**MODIFICATION REQUEST:
*WestConnex M4 Widening - Modification 1***

***Cycleway Diversion of the Homebush Bay
Drive Interchange
SSI 6148 (MOD 1)***

Secretary's Environmental Assessment Report
Section 115ZI of the
Environmental Planning and Assessment Act
1979

July 2015

Figure 2 – Proposed Off-Road Cycleway Alignment at the Homebush Bay Drive Interchange with the M4 Motorway (Source: Proponent's Modification Report)

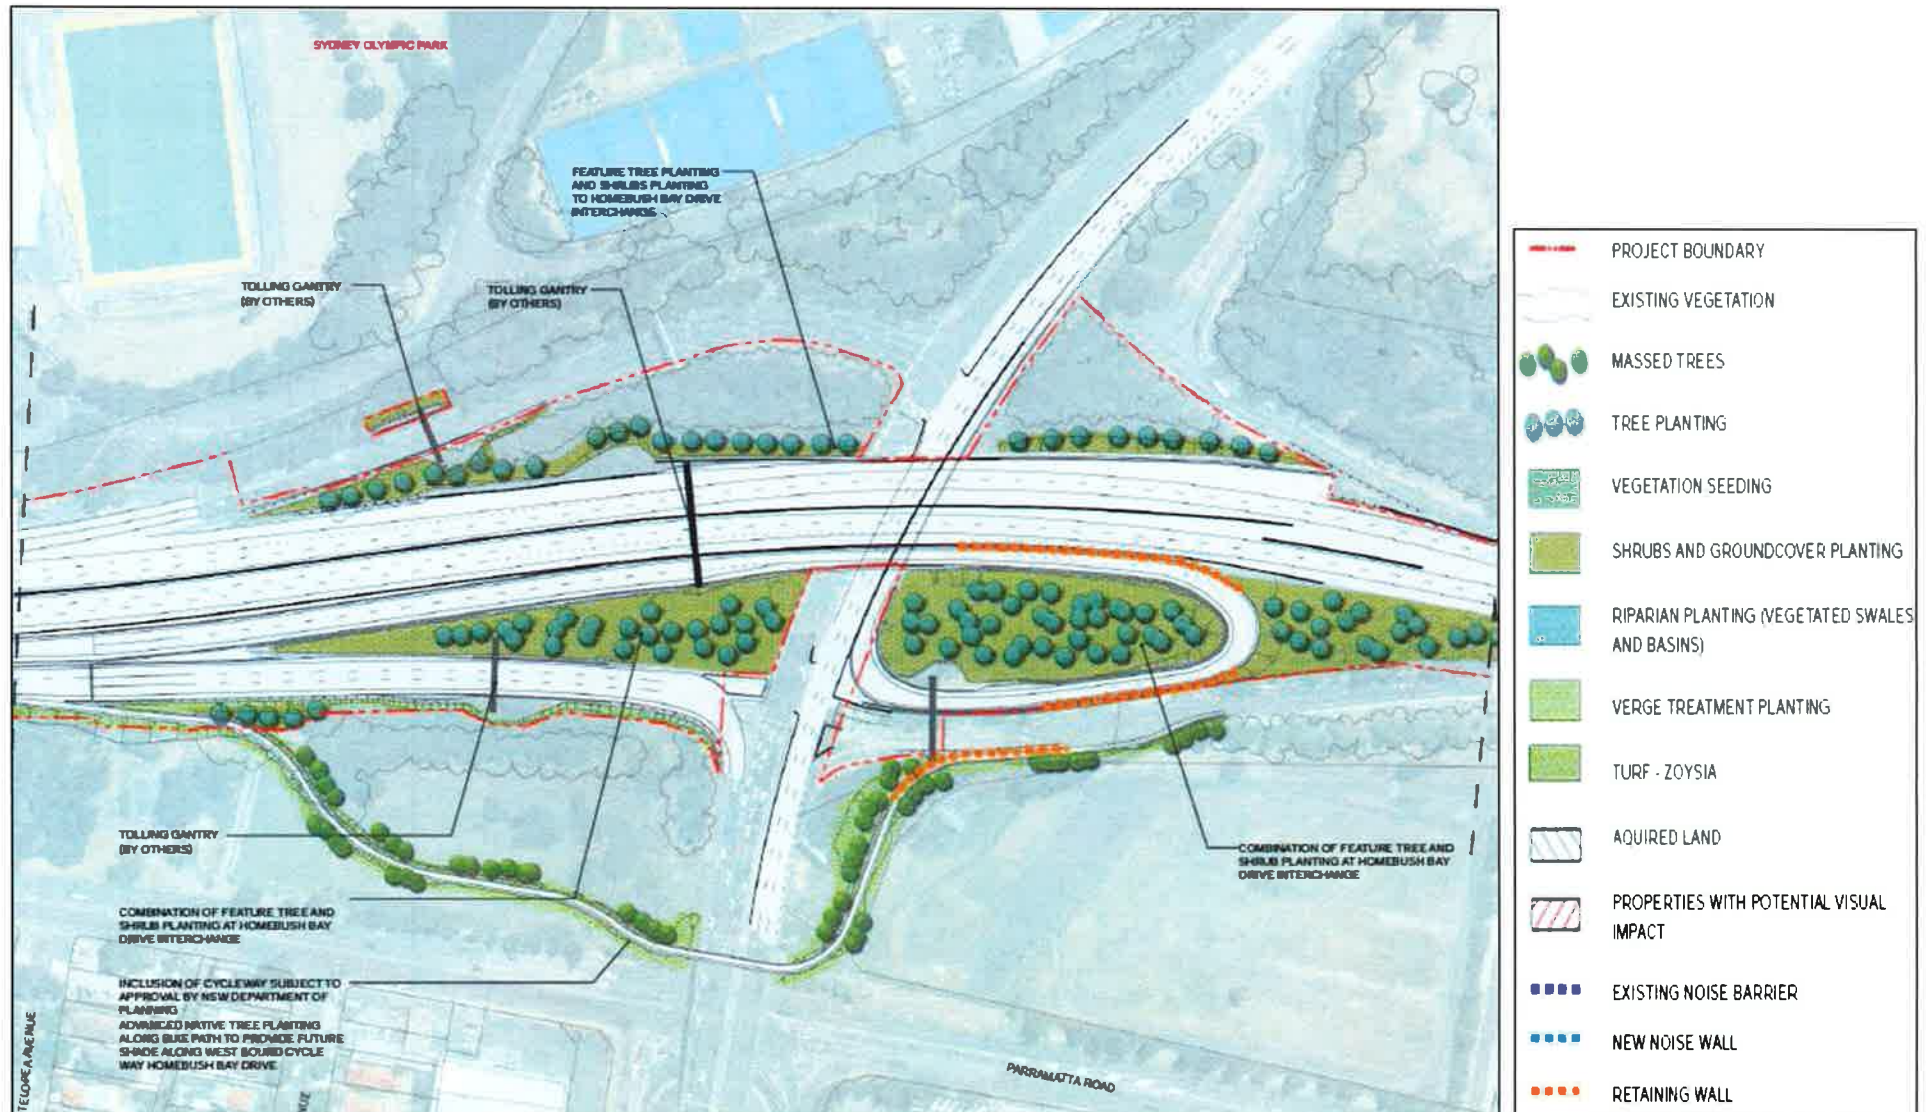
Auburn City Council indicated in-principle support for the project and made recommendations on the grade of the cycleway and for it to avoid a nearby low drainage point. It also recommended that the path width be increased to three metres and that the path connect to Parramatta Road.

Bicycle NSW suggested that the cycleway path width be increased to three metres, grades be minimised and that ramps be provide to and from Parramatta Road.

Auburn City Council and Bicycle NSW requested the proposed cycleway be widened from two metres to three metres to cater for passing riders and build capacity for future use. The Department, however, considers the proposed width of two metres provides adequate space for cyclists given it will cater for one-way (westbound) cycle traffic only and provides adequate space for overtaking. The proposed path width is consistent with the document *Guide to Road Design: Part 6A Pedestrian and Cyclist Paths* (Austroads, 2009) which recommends a one-way path width of 1.2 metres to two metres. Consequently, the Department has not adopted Auburn City Council's and Bicycle NSW suggested path width.

Auburn City Council and Bicycle NSW also recommended that consideration be given minimising the grade of the ramp to the Motorway and ensuring that the route avoid the drainage pit and low point around chainage 200 as the path could otherwise be subject to flooding, creating a potential hazard for cyclists. The modification report submitted by RMS indicates that it will refine the gradients and route in the vicinity of the depression and drainage pit during the detailed design. The Bicycle Road Safety Audit recommended by the Department would provide a mechanism for ensuring that this commitment has been adequately addressed.

Both Auburn City Council and Bicycle NSW recommended that the cycleway provide for connectivity with Parramatta Road. The Department does not support the inclusion of informal access to and from the off-road cycleway from Parramatta Road given there is no formal provision for cyclist and pedestrian paths on the northern side of Parramatta Road. Furthermore, the Department considers that provision of such a connection would increase the risk of pedestrians entering the off-road cycleway diversion from Parramatta Road, with subsequent access to the M4 carriageway. Until such time the cycle infrastructure is formalised in the local area, access or egress opportunities to Parramatta Road should be discouraged. However, it is considered the cycleway design should not preclude future formal access or egress points being established at this location. Consequently the Department has recommended that condition B14 of the infrastructure approval be modified to include that the project is designed so as not to preclude future connectivity of the off-road cycleway diversion with future cycleways.

The changes proposed to the existing cycling arrangement in the vicinity of Homebush Bay Drive may be temporarily confusing, particularly for cyclists who regularly use the M4 Motorway shoulders in this vicinity. As such, the Department recommends the Proponent be required to install permanent signage to alert cyclists of the changed cycling conditions, and to provide directions for access to the off-road cycleway, and has recommended a condition to this effect. The recommended condition also requires the signage to advise that cyclists are prohibited on the Motorway in this vicinity.

The Department also recommends that the infrastructure approval be amended to include a condition requiring the Proponent to conduct a Bicycle Road Safety Audit to assess the safety performance of the proposed off-road cycleway. The Audit is required to be undertaken by an appropriately qualified person during the detailed design phase to ensure the relevant guidelines and safety standards are achieved as part of the design.

Condition B14 of the infrastructure approval requires that the design of new or modified cycle infrastructure meets the requirements of the relevant design, engineering and safety guidelines. The Department is of the opinion that this requirement, supplemented with the recommendation for a Bicycle Road Safety Audit, will ensure that the cycleway provides safe access for cyclists.
